PLANNING COMMISSION STAFF REPORT

| Originator Kris Aaker, Assistant Planner | Meeting Date February 25, 2015 | Agenda # B-15-05 |

DATE: February 18, 2015
TO: Cary Teague – Planning Director
CC: David Fisher – Building Official
Ross Bintner P.E. - Environmental Engineer
FROM: Charles Gerck EIT – Engineering Technician
RE: **4141 44th St West - Special Review of Variance Application**

VARIANCE APPLICATION

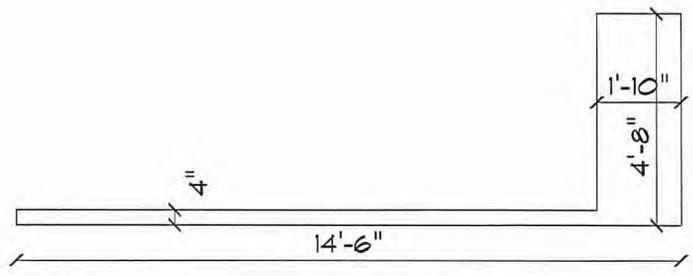
I just spoke with Jeff Tritch the architect. Attached is his drawing of the part that needs to be removed to be in compliance with the hardcover requirements. We have settled on taking 4 inches off of the garage, 6 inches off of the master bathroom/closet and the remaining 12.28 sq ft coming off of the front step/porch. Do you want me to come by this morning and yellow them in as suggested or is his attached revised drawing sufficient?

9.7 sq/ft = GARAGE

12.8 sq/ft = FRONT PORCH

12 sq/ft = MASTER BATH/CLO.

34.5 sq/ft = TOTAL REMOVED

TOPOGRAPHIC BOUNDARY SURVEY FOR: Gary Gosewisch

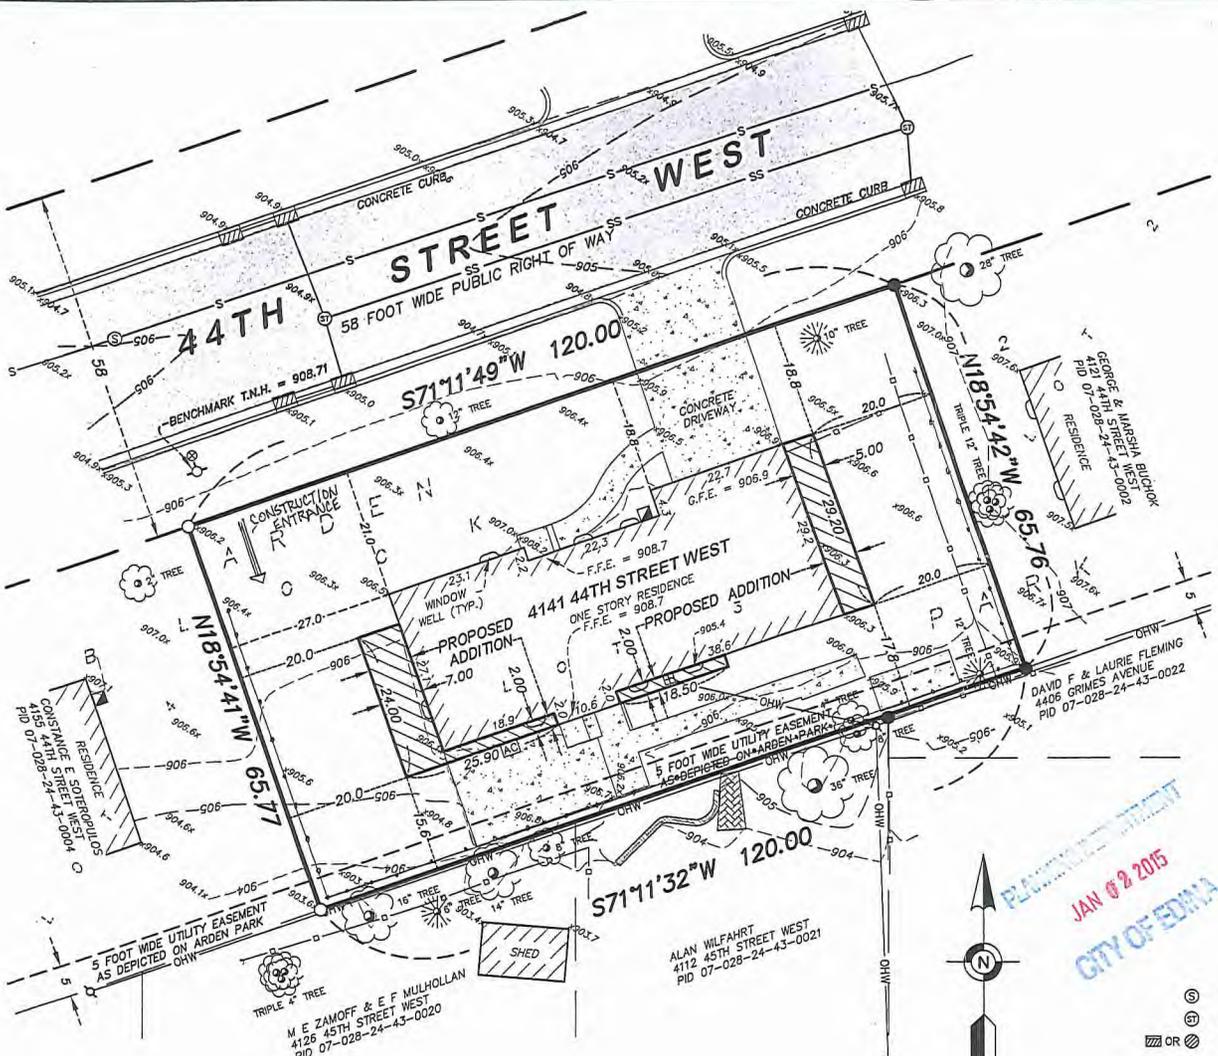
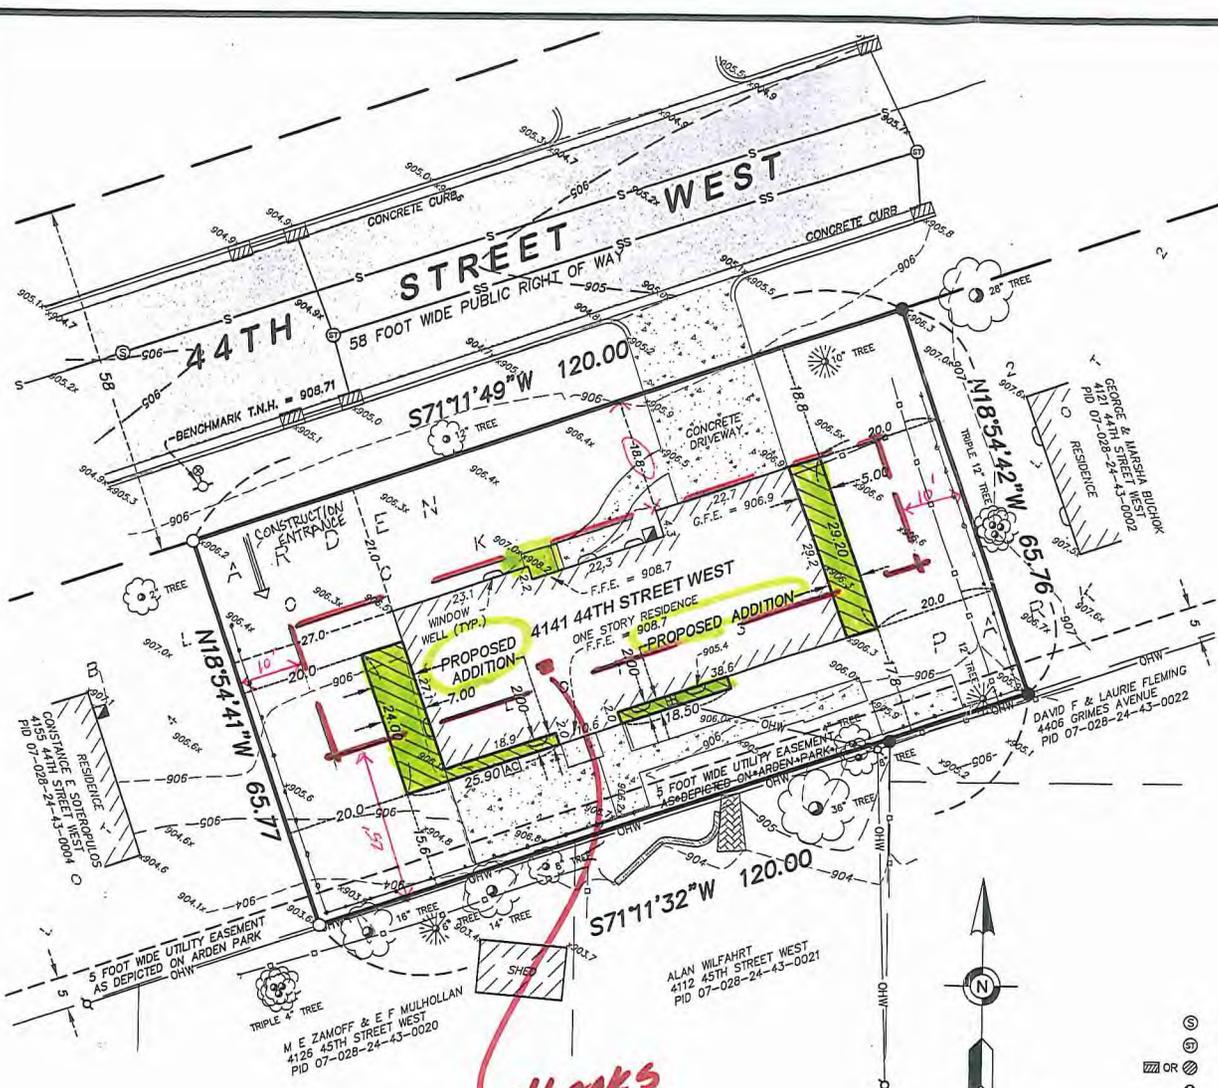
I was reviewing your variance application in more detail and one of the submitted surveys indicates a total proposed house footprint of 2,254 square feet. The maximum allowed coverage is 2,250 square feet. It also doesn't look like the surveyor put the front portico on the survey. So I doubt that was included in the proposed footprint amount. Would you please check with the surveyor regarding the front portico and coverage amounts. It would appear that you will need a lot coverage variance so you will need to address that variance once the amount over 2,250 square feet is identified by the surveyor. A lot coverage variance is not a variance that City Staff can support.
